Campaign No. 2018030003, March 2018

SUBJECT: **Model 906, Model Years 2016 - 2017**
Replace Body Manufacturer Information Label

Figure 1. Information Sticker

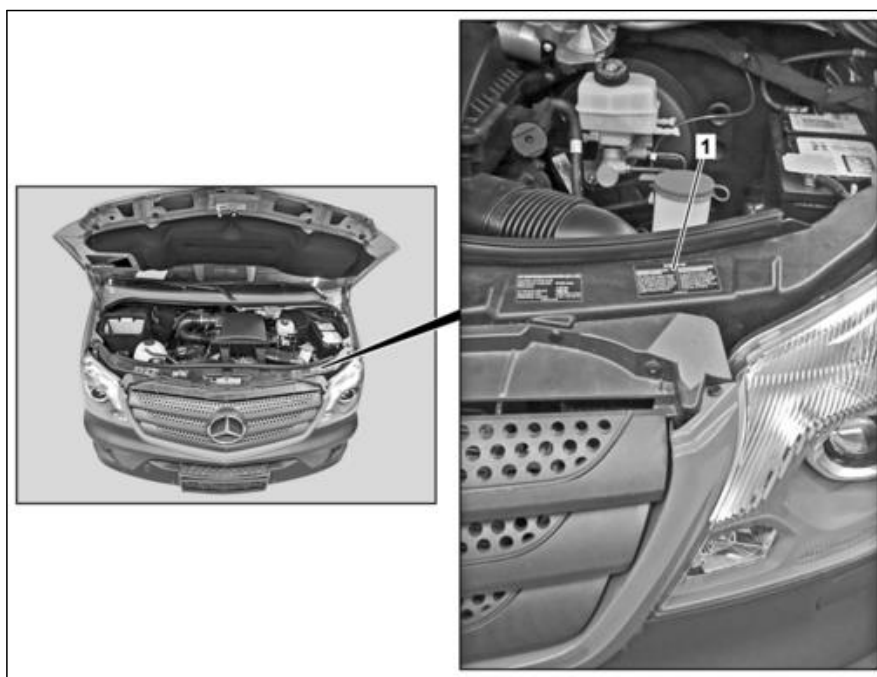
Daimler AG, the manufacturer of Mercedes-Benz Sprinter vehicles, has determined on certain Mercedes-Benz Sprinter vehicles with folding seats and a total permissible weight of under 10,000 lbs., the information label for subsequent/ final stage manufacturers contains incorrect information regarding the unloaded vehicle weight (UVW). Should the maximum UVW be exceeded, certain side impact protection requirements might not be met. This could result in an increased risk of injury in the event of a crash. An authorized Mercedes-Benz Sprinter dealer will check that the UVW of your vehicle is not exceeded and replace the UVW label.

Check		
1	Check whether the vehicle is affected by the measure	For authorized Mercedes-Benz service partners, only the entry in the "Extended VEGA Application" (EVA) system, in the "Current" tab is decisive. An additional test of the affected vehicles in the workshop information system (WIS) or vehicle list is thereby not necessary.	
	Replace		
2	Replace information label (Figure 1) 000 588 00 84 00 Heat gun	Bonding surface must be absolutely free of dust and grease. Otherwise, a sufficient degree of adhesion cannot be assured. To do so, use suitable tool (e.g. heat gun) to remove information label (1) and remove any adhesive residue using suitable cleaning agent.	WS54.00-P-0049B
	Measure using pointer device		
3	Determine vehicle curb weight	To determine the vehicle's curb weight, weigh the vehicle when unladen. If the curb weight of the vehicle is greater than 6724 lbs., generate TIPS case.
